**April 21, 2025**

**Project: FTW Apron B and Taxiway G Reconstruction Project  
TxDOT CSJ No. 2502MCHAM  
Addendum No. 1  
To Plans and Contract Documents**

**To:** Attendees  
**From:** Alex Jessop, PE  
**RE:** Fort Worth Meacham International Airport (FTW)  
Apron Bravo and Taxiway G Reconstruction  
Pre-Bid Meeting Minutes

1  
EL-502

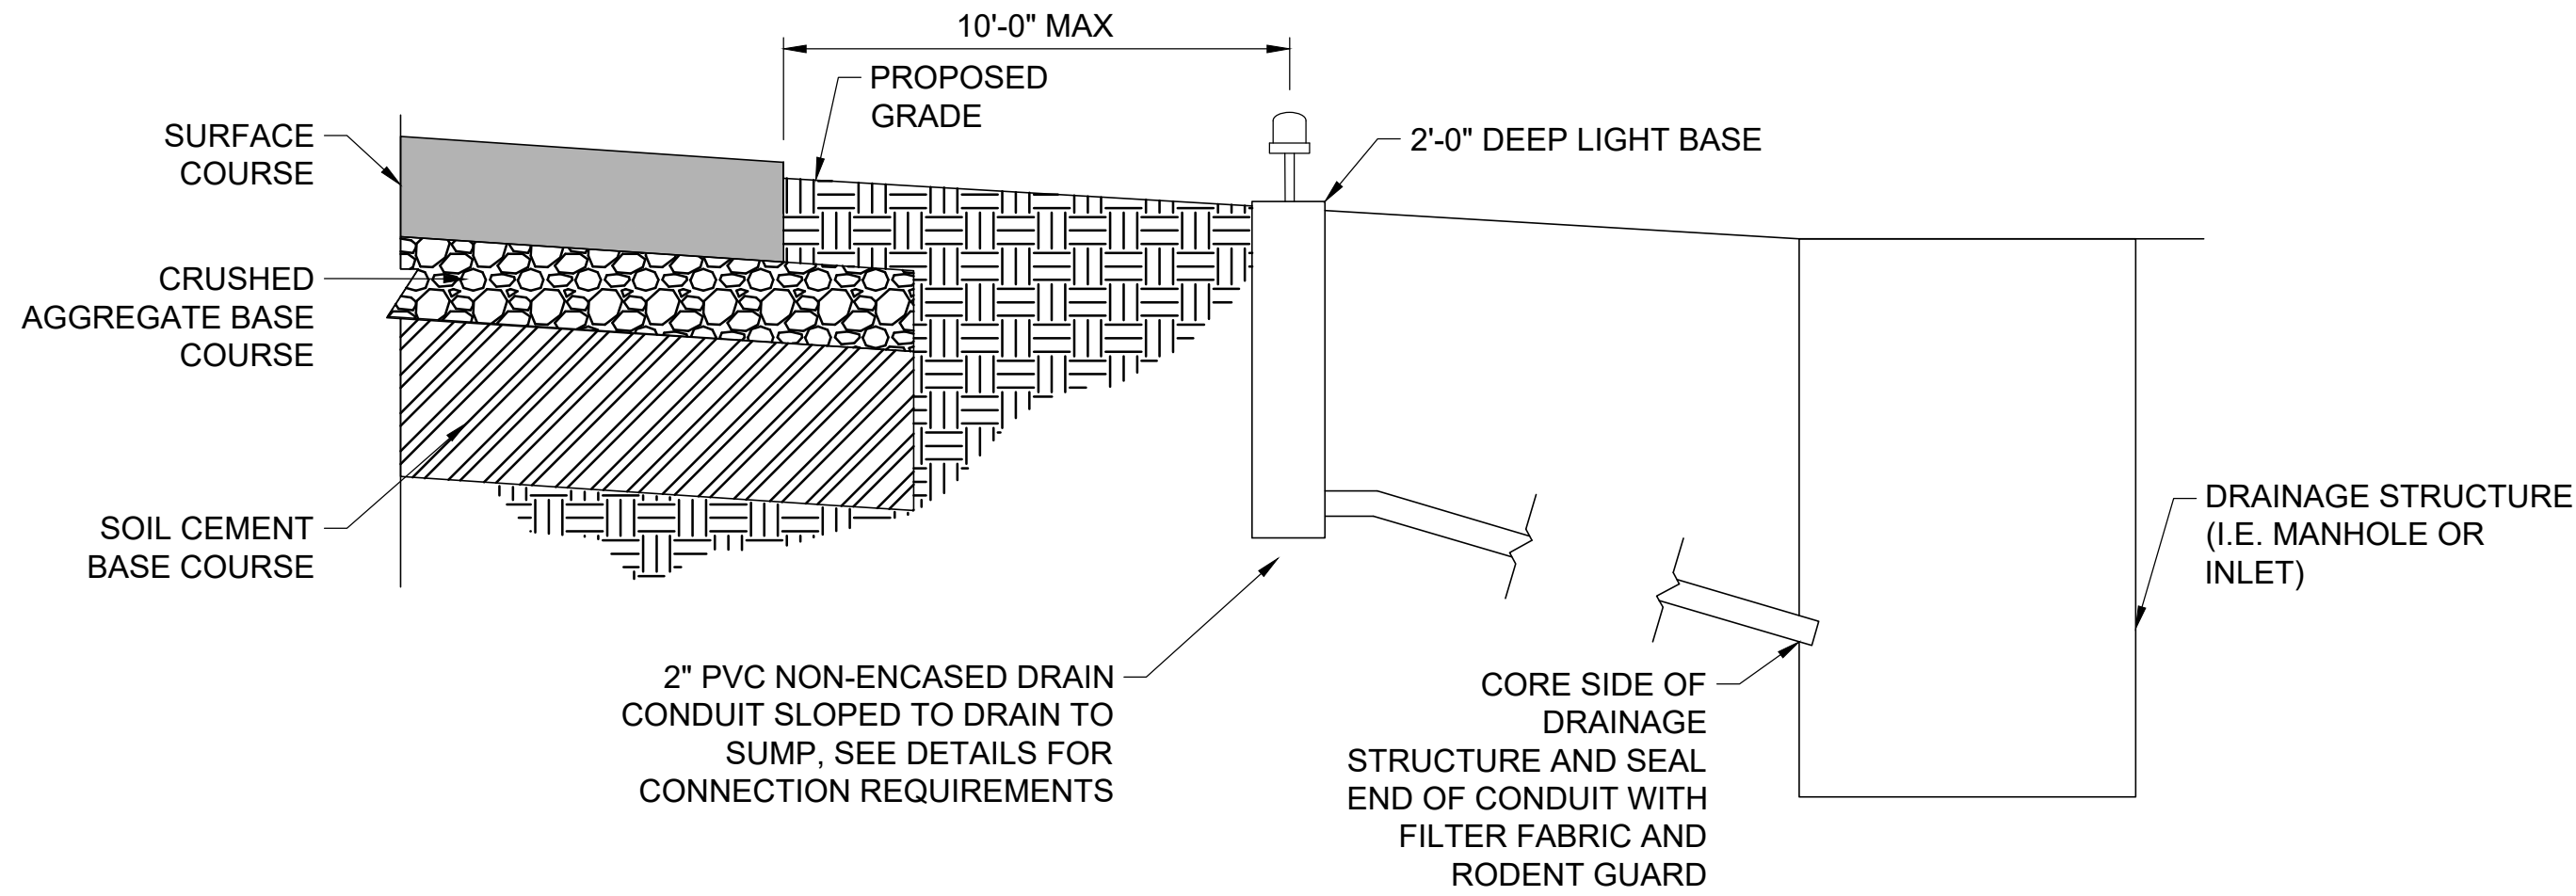
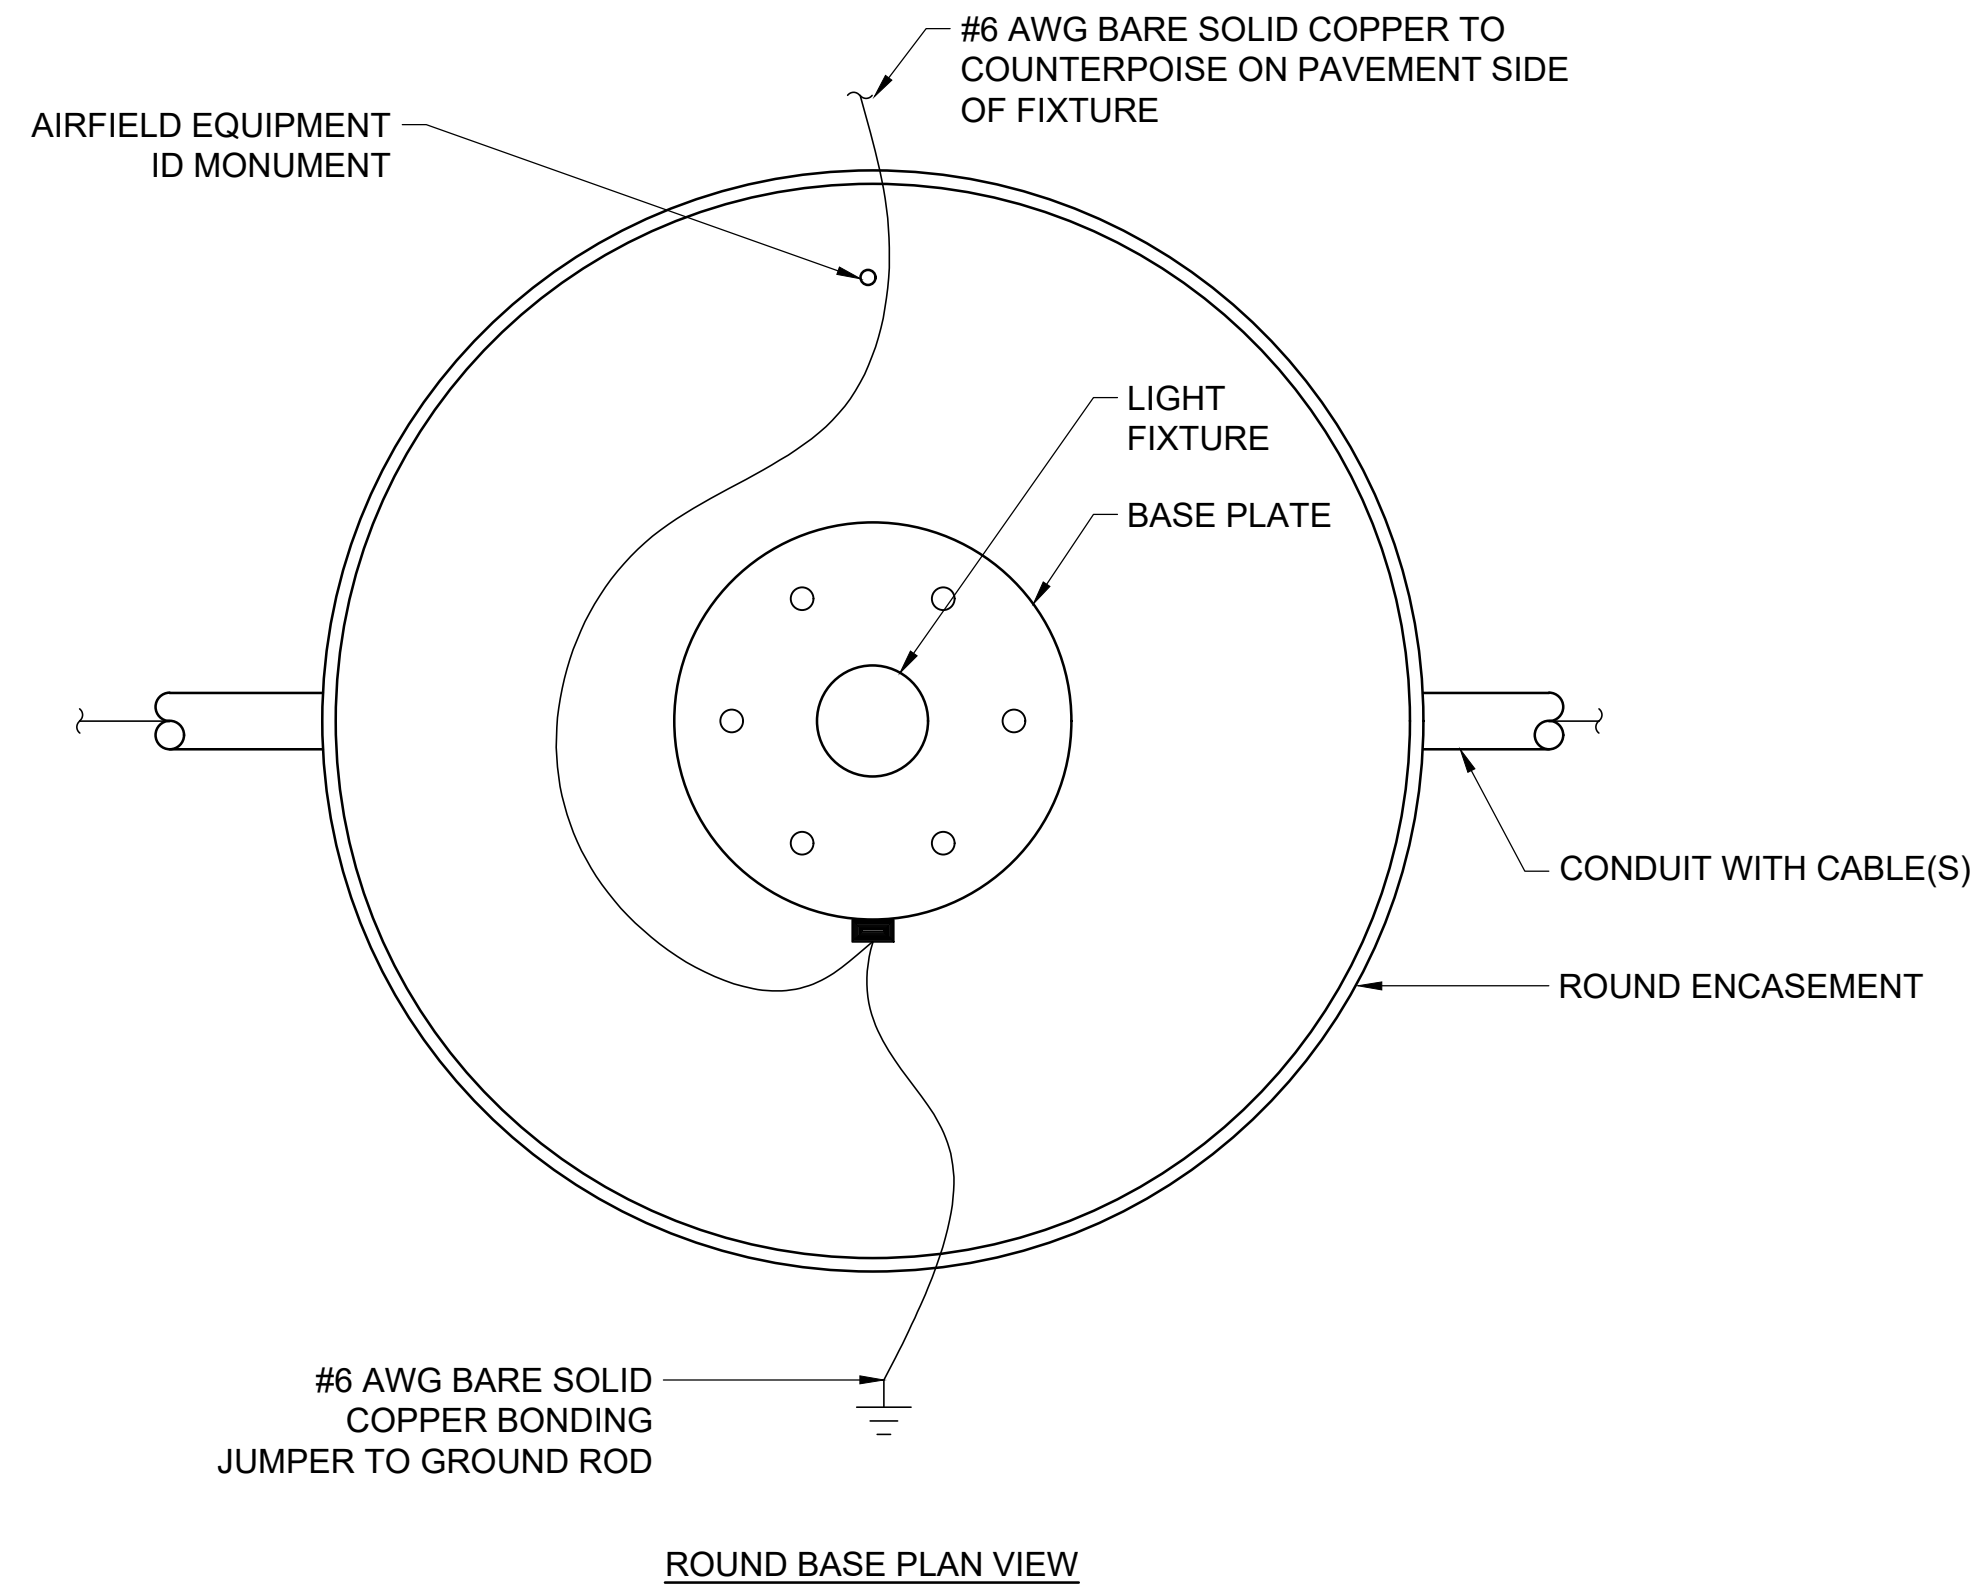
- a. Compensation for this will be covered under Item C-105-6.1 Mobilization. See section 120-3.1 of the specifications.
25. Referencing drawing EL-502, note 4 is calling for a 1" drain conduit from the light base can. Detail 2 on the same sheet is showing a 2" conduit for the drain. What is the correct drain conduit size?

- a. The drain conduit shall be 2" PVC. The drawing showing the 1" conduit will be revised to show 2" conduit.
26. Is the contractor to provide a drain sump, per note 4, for every new edge light base can or only the base cans installed in non-paved shoulder?

- a. Drainage conduit is only required where shown on the plan view drawings. Note 4 for detail 1, sheet EL-502 will be revised to reflect this change.
